SUNDRY NOTICES AND REPORTS ON WELLS

8. Well Name and No.  
Yates 8 Federal #2  
(300759)

9. API Well No.  
30-015-31499

## **Conditions of Approval**

**CURRENT STATUS**

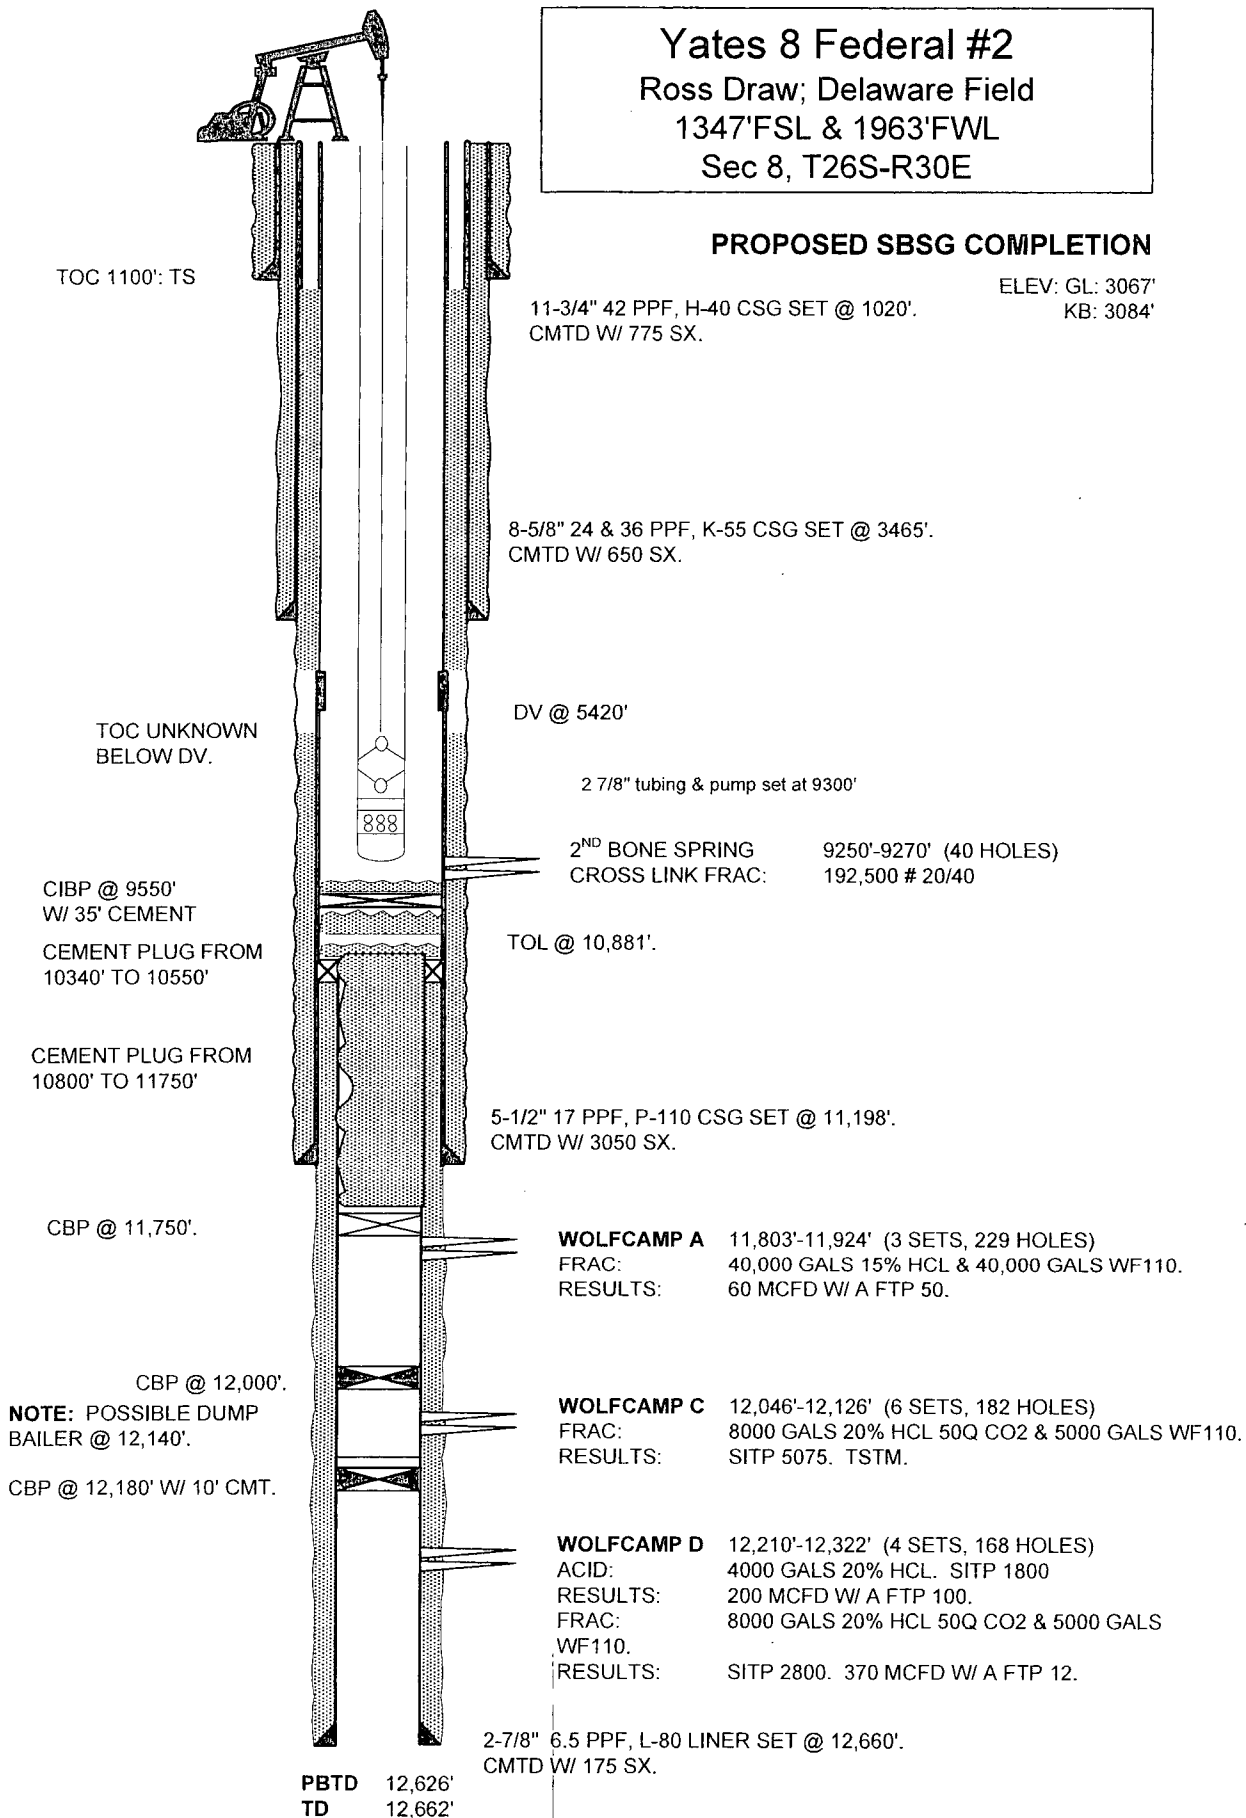
11. Operator shall also drill out the packer assembly at 10,875'.
12. CIBP shall be set at 11,750' (a smaller CIBP will be required as that is in the 2-7/8" liner) and a minimum of 30 sacks of Class H cement placed on top of the CIBP. This will cover the 5-1/2" shoe and the liner top at 10,881'. Plug shall be tagged at 10,800' or shallower. Plug shall be pressure tested to 1000 psi with test recorded on a chart and witnessed by the BLM.

13. Set a neat Class H cement plug across the top of the Wolfcamp. Plug shall be a minimum of 210' in length, a minimum of 25 sacks and shall be set from 10,550' to 10,340'.

14. Operator's step 6 is not necessary, but if operator wants to set a CIBP at 9550', operator may set the CIBP, but is required to cap it with 35' of Class H cement. This will be tagged to verify 35' of cement.
